City Planning Commission
Sacramento, California

Subject: Special permit to develop a 596+ sq. ft. restaurant with two drive-up windows
(P87-046)

Location: Northeast corner Rimmer Avenue and Northgate Boulevard

EXHIBIT 1
STAFF EXAMPLE

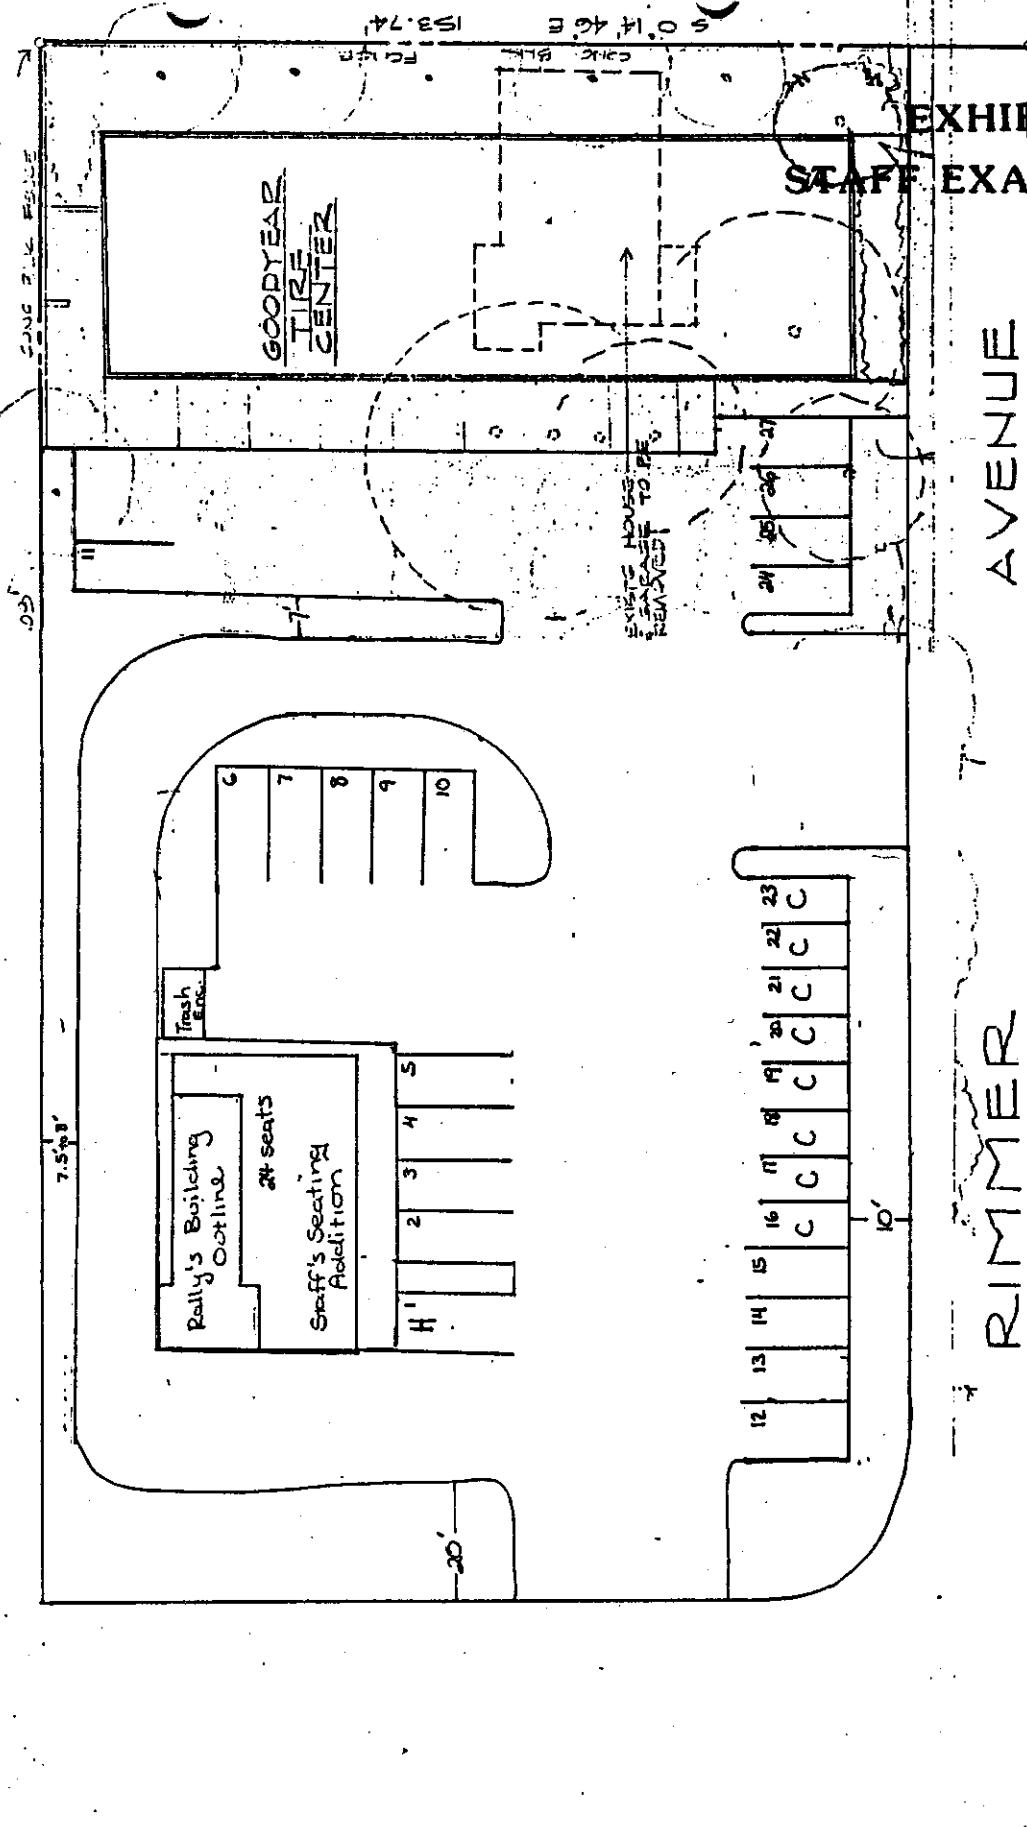
Staff, however, continues to find that the proposed restaurant with two drive-up service windows is inappropriate for the site in that there is too much paving on the subject site and there are several problems with the proposed circulation pattern. The surrounding area is developing with several retail commercial uses which could benefit with an indoor seating area. Planning and Traffic Engineering staff find that the project should be redesigned to eliminate one drive-up service window and add indoor seating (Exhibit 1). Staff, therefore, recommends denial of the applicant's request.

EXHIBIT D

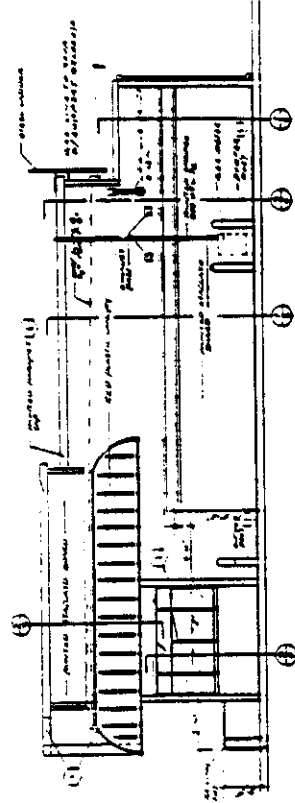
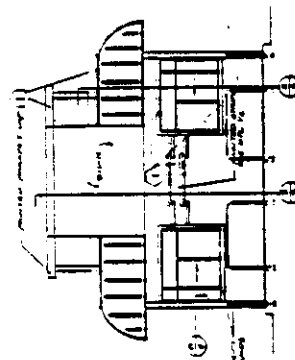
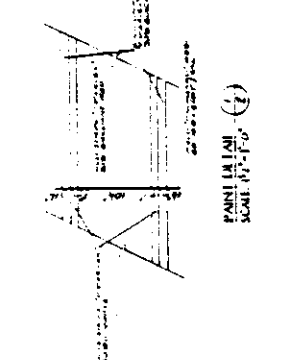
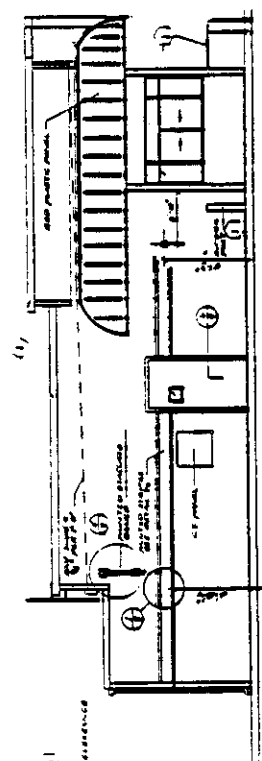
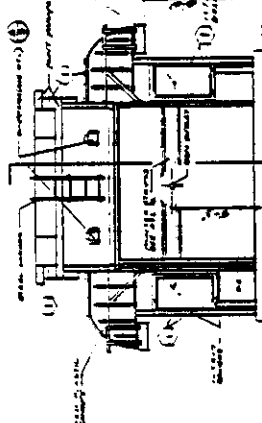
The proposed Rally's building is proposed to have a stucco exterior painted beige with a red accent stripe around the building (Exhibit D). Red plastic awnings are proposed to cover the two drive-up windows and two walk-up windows. An attached identification sign is proposed for the west elevation. Staff finds the proposed elevations to be stark and lacking in interest. More design variation and detail is needed.

Staff's Example Of A
Revised Site Plan

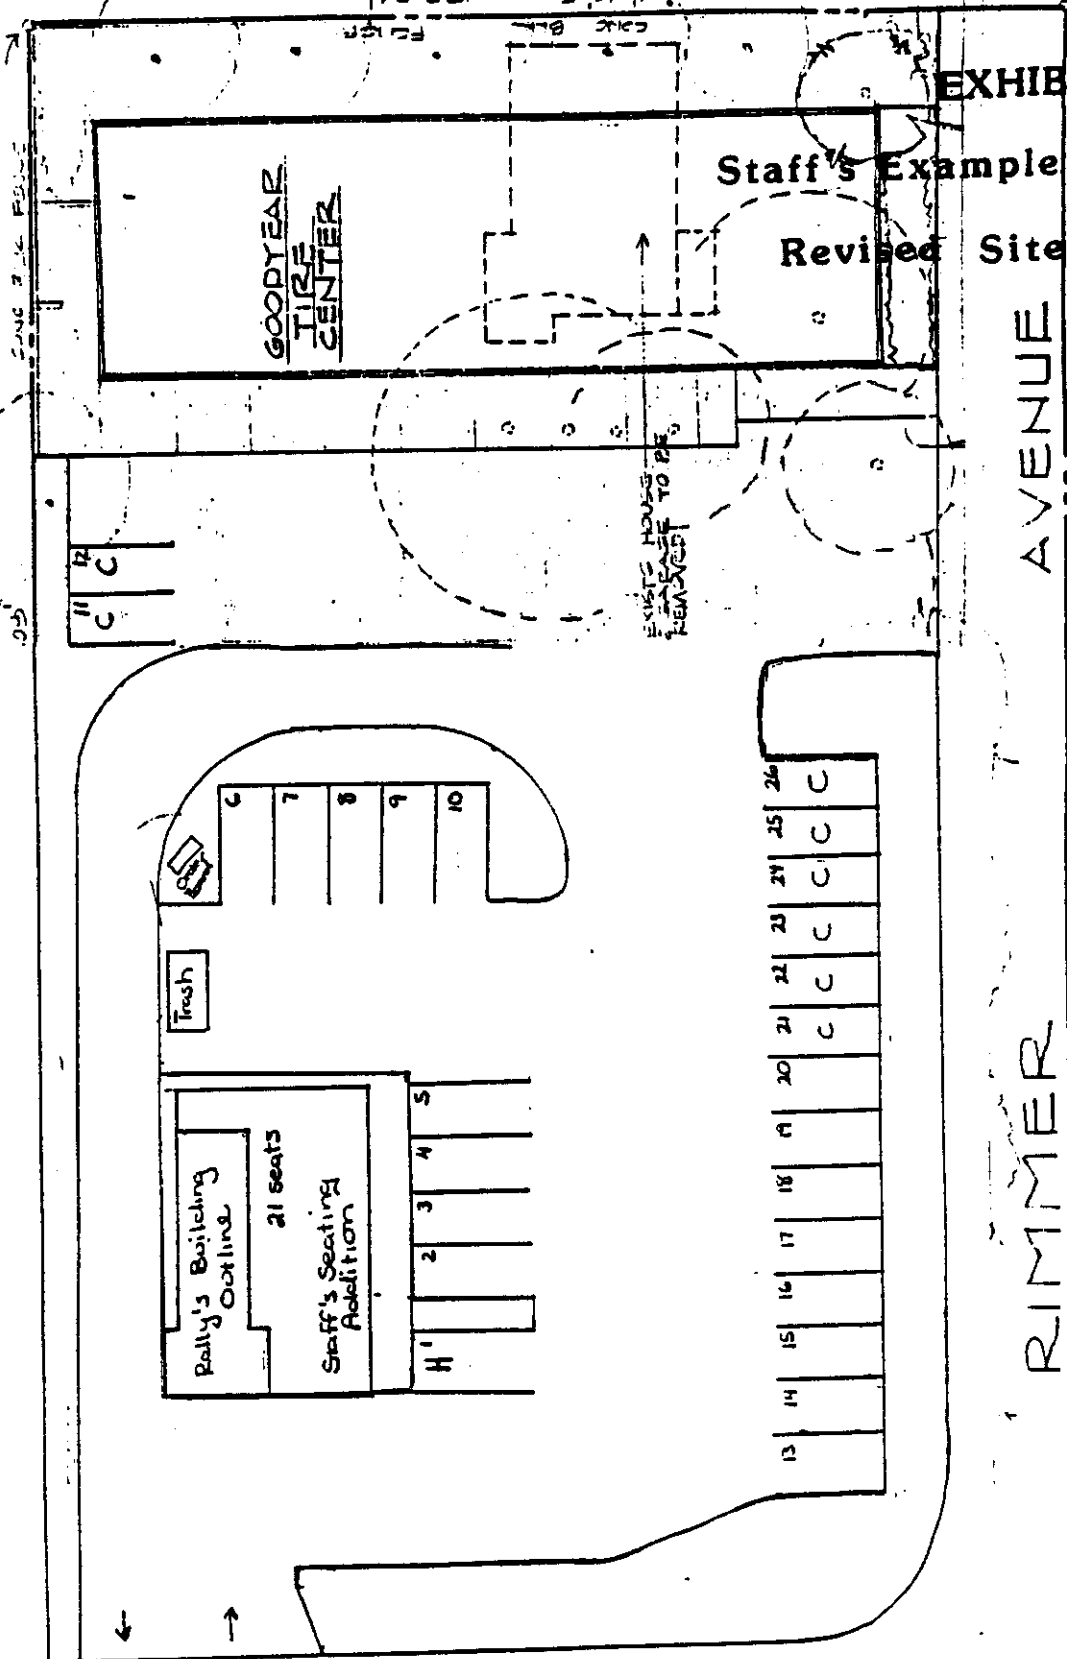
Planning Staff met with the applicant and recommended that the site plan be redesigned to eliminate one drive-up service window, add an indoor seating/dining area, reduce the amount of paving and solve the existing circulation problems. The applicant submitted a revised site plan redesigning the circulation pattern and adding an outdoor seating area and landscaping (Exhibit B). Planning and Traffic Engineering Staff find this site plan to be unacceptable in that: inadequate parking is provided for the number of seats indicated; indoor seating is not provided; adequate stacking distance for vehicles is not provided; drive-through lane should accommodate a minimum of six vehicles; and there are still circulation problems with the proposed design. Planning and Traffic Engineering Staff find that the project should be redesigned to eliminate one drive-up service window and add indoor seating (Exhibit C). Staff, therefore, recommends denial of the applicant's request.

Original Site Plan

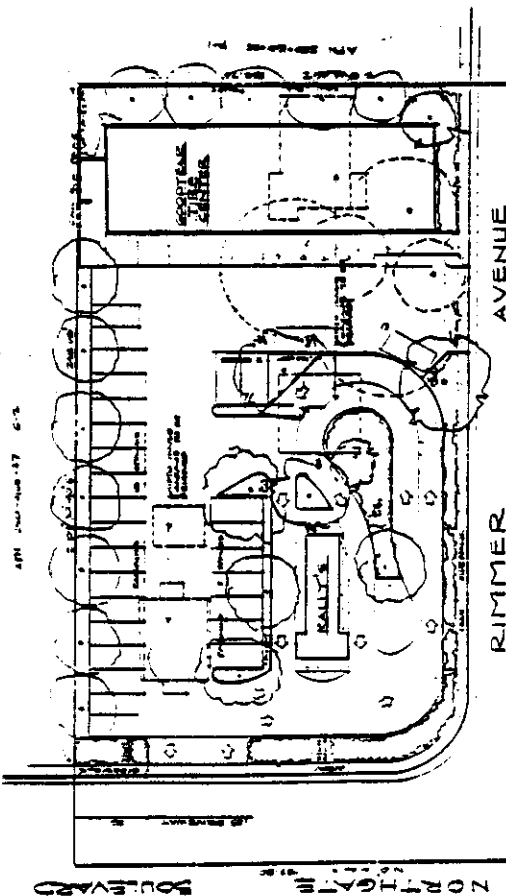
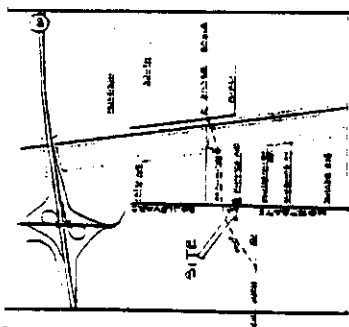
The submitted site plan indicates the proposed tire center at the rear of the site and Rally's located at the front of the parcel facing Northgate Boulevard (Exhibit A). The minimum 10-foot planter along Northgate Boulevard and five-foot planter along Rimmer Avenue, as proposed by the SPD Ordinance, are provided. Staff finds, however, that the majority of the site (66 percent) is devoted to paving for driveways, drive-up service lanes and parking. Staff recommends additional landscaping to improve the appearance of the site.

Trash enclosure facilities have not been indicated on the site plan and need to be provided.

The submitted site plan indicates two detached-pole signs along Northgate Boulevard. The Sign Ordinance permits only one detached sign per street frontage per parcel. Any detached sign should meet the design requirements of the proposed SPD Ordinance. A sign program for the drive-up windows should also be provided.

The site plan was also reviewed by the City Traffic Engineering Division. Traffic Engineering indicated several problems with the proposed circulation pattern. These problems included: inadequate width for drive-up service lanes; an unacceptable design around the Northgate Boulevard driveway creating vehicle congestion and

circulation problems; concern that drivers using the southern drive-through lane will have difficulty judging how close their vehicles are to the window and problems getting their food from the opposite side of their automobiles. A redesign of the site plan is recommended.
